**Mont-Joli Airport, Quebec
Former Building H-3, Former Coal Depot and Former Landfill**

Remediation Plan

**Responses to the Supplemental Information Request from MDDEP
dated July 20, 2011,
Concerning Remediation of the Former Hangar H-3 Sector**

Dessin / Drawing:
FIGURE 15.1
Localisation des puits d'observation
et du panache de contamination

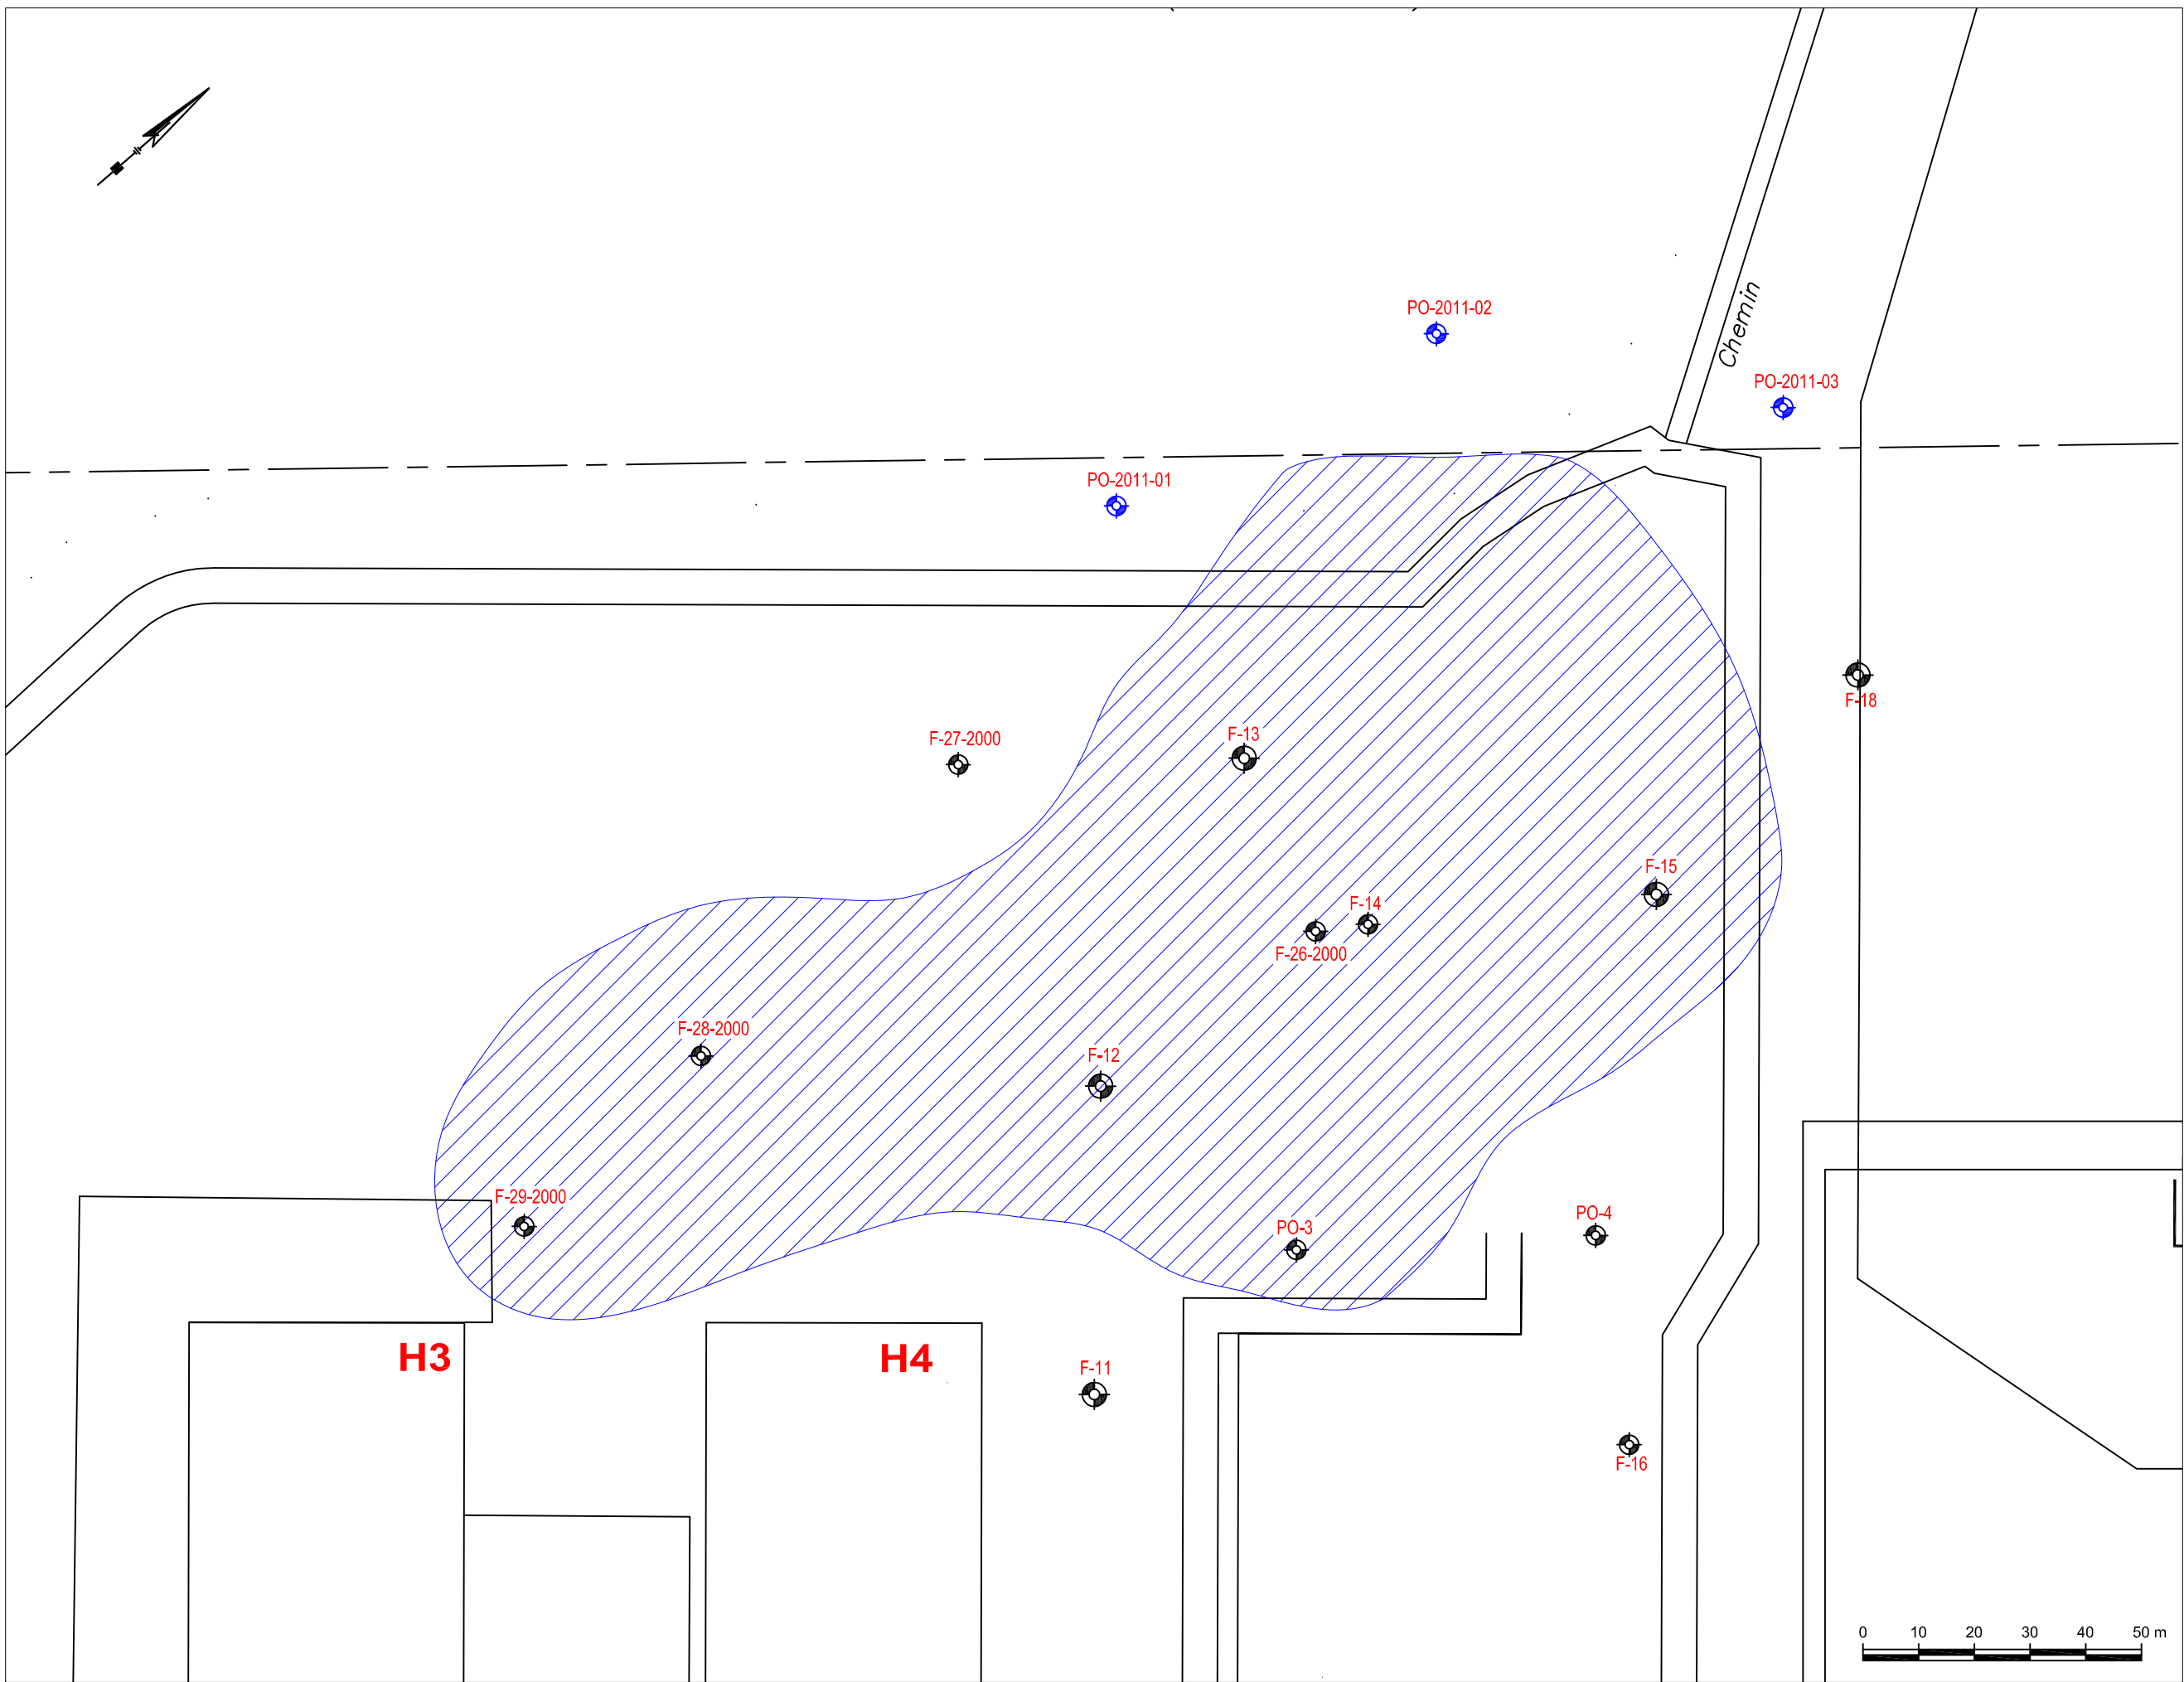
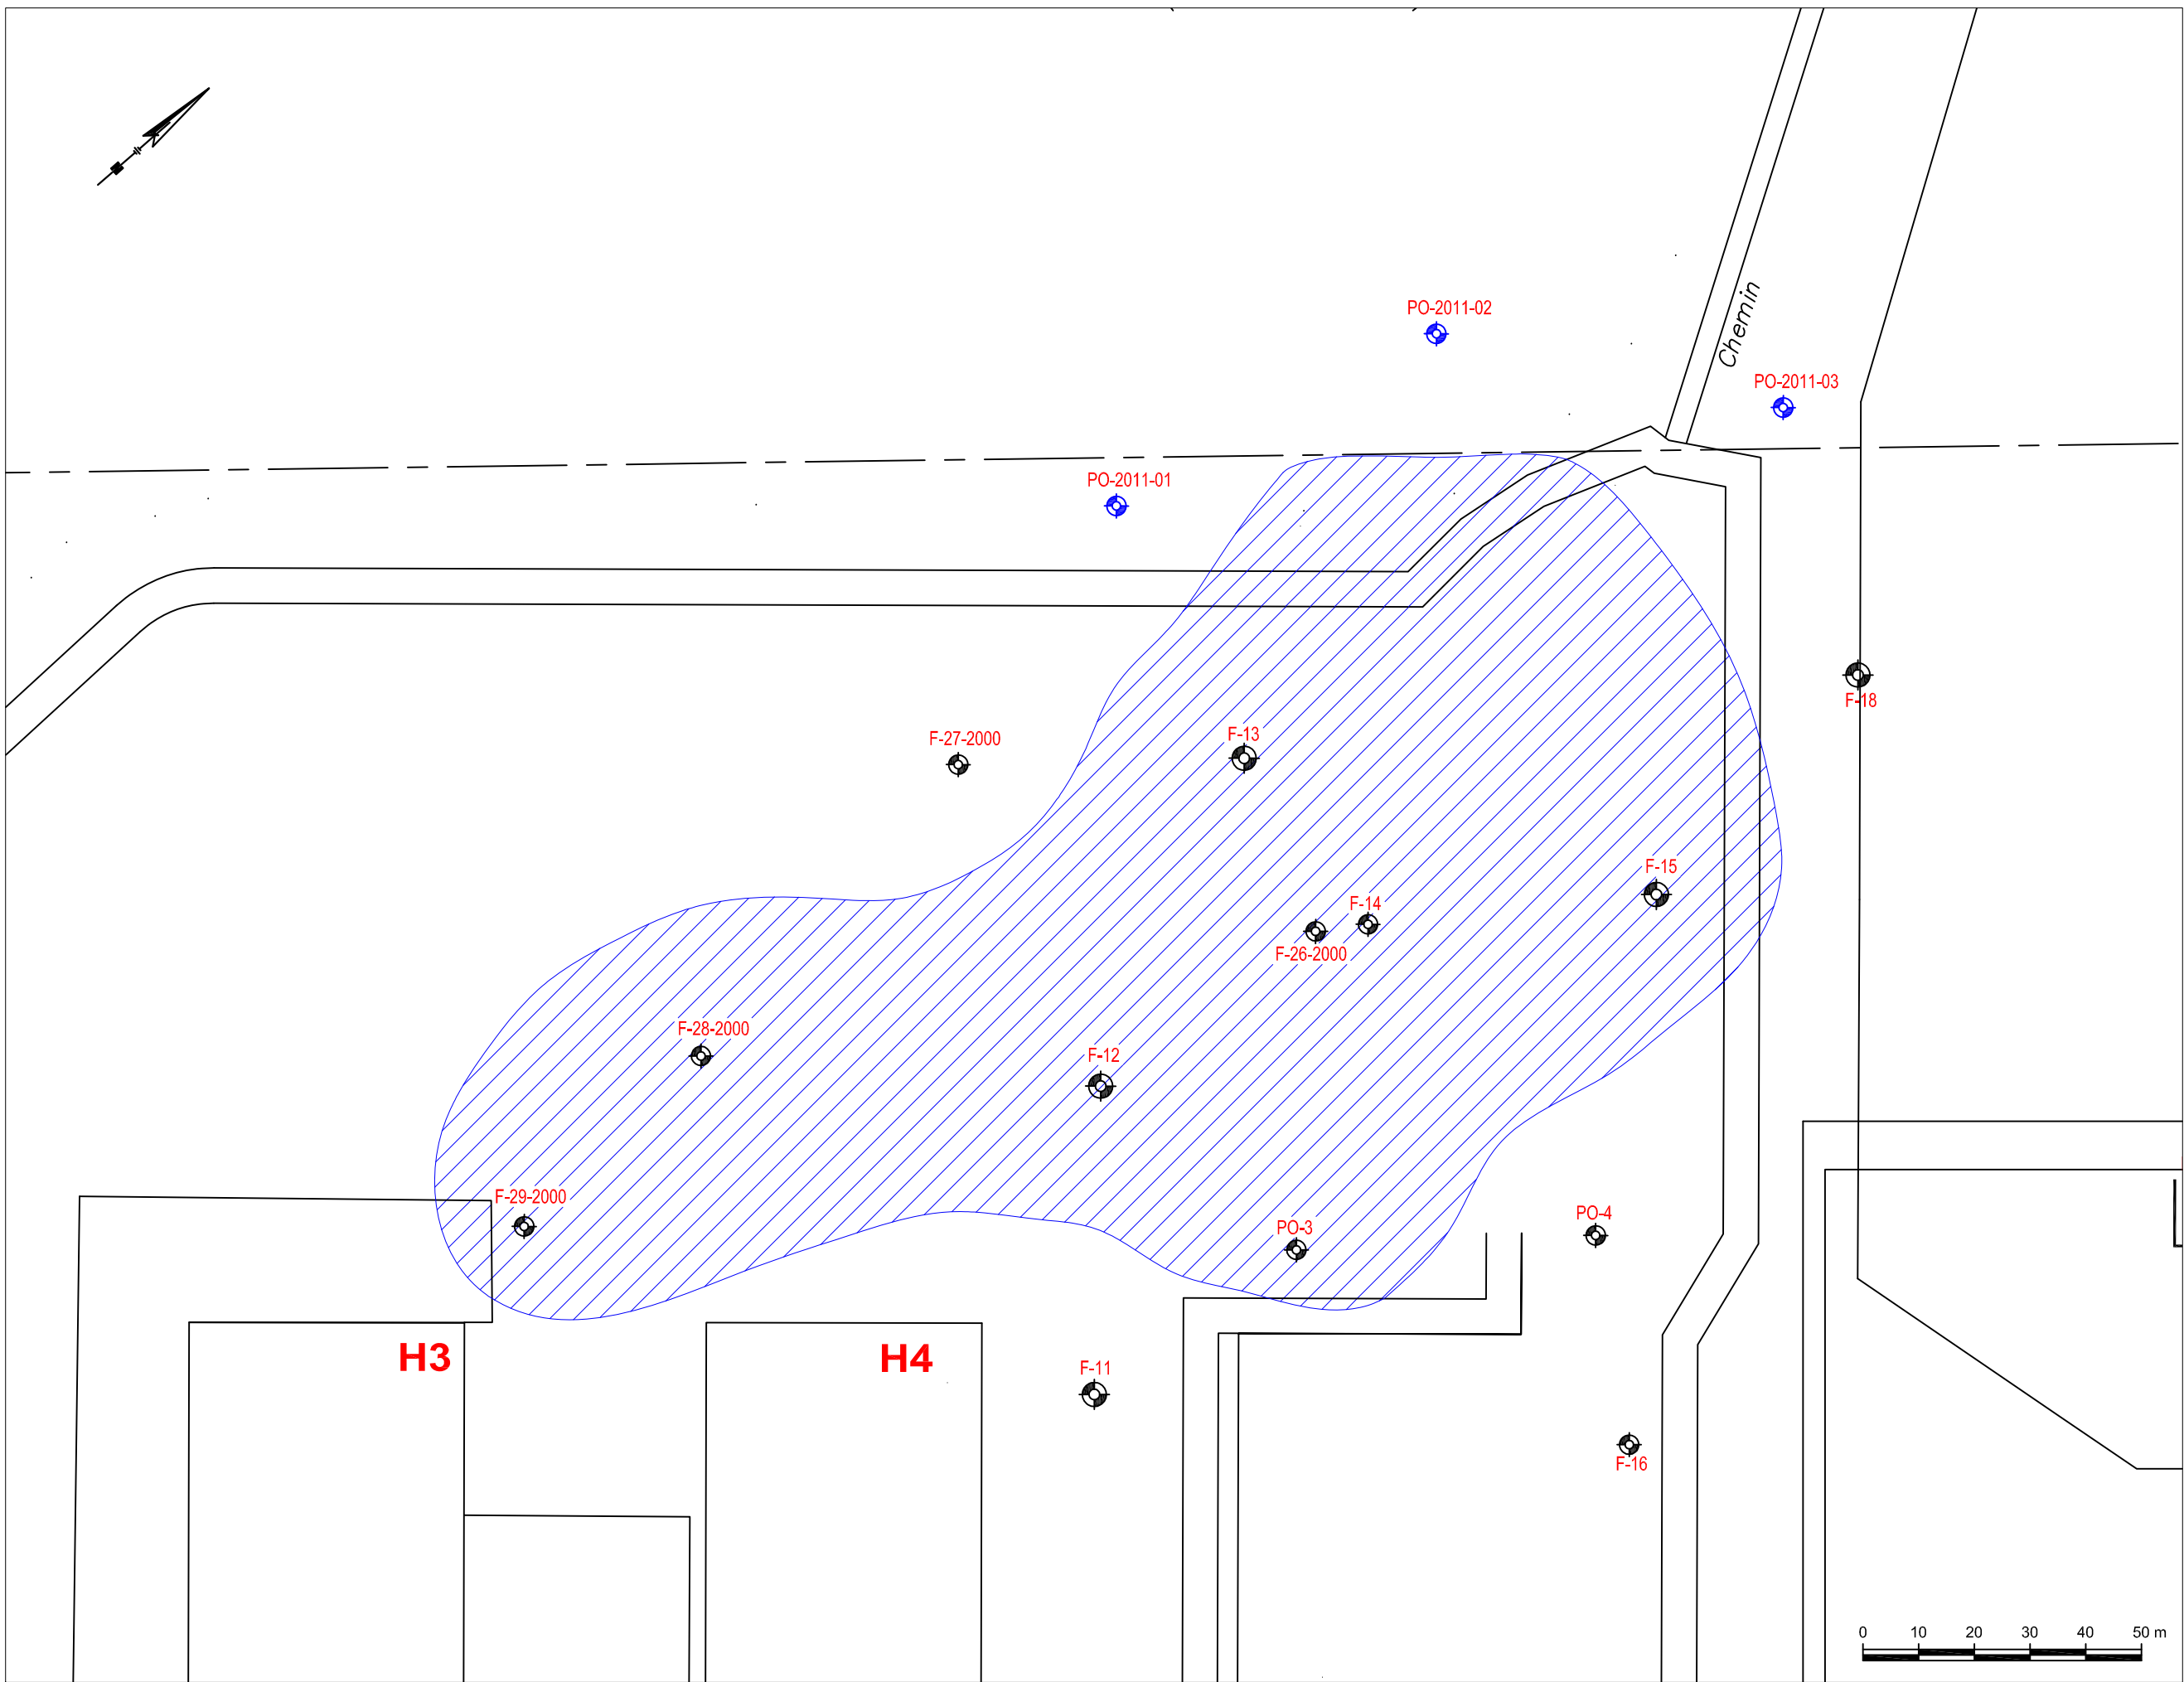
16. Because of the scale used in the figures, the contaminant plume cannot be displayed on Figures 3.1 and 4.1 of the Plan. This contaminant plume, identified in the previous studies, is presented in Figure 15.1 (Annex 2), together with the existing wells and those to be constructed. Note that other wells could be added based on the results of the site characterization currently underway.

The results of the groundwater characterization for the new monitoring wells will be used to plan the groundwater quality monitoring program for the entire lot. In addition to the existing wells (about 13 wells) and wells to be constructed (about 3 wells) northwest of the contaminant plume identified in the previous studies (see Figure 15.1 in Annex 2), other wells installed as part of the site characterization could be added to the monitoring program.
